PATRIOT CUSTOM METALS

ARUNA SUN SHADE

AMERICAN FENCE PROJECT #: .		CLIENT PROJECT #: .	
REFERENCE JOB #: .			
CHKD BY: AF .	SCALE: N.T.S.	DRAWN BY: AF DATE: 3/5/24	REV A SHEET # 02

A CONNECTION DETAIL
PLAN VIEW

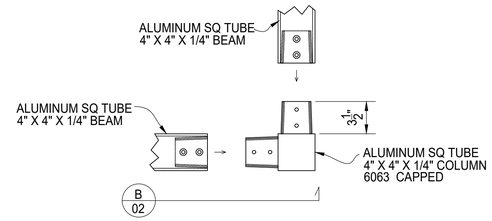
REV	DESCRIPTION	DATE
A	CONNECTION DETAILS CHANGED. BOLTING INTO THE PURLIN INSTEAD OF THE BEAM.	08/20/2024
A	ADD ALUM GRADE AND INCREASE THICKNESS OF THREADED PLATES	09/18/2024 (AF)
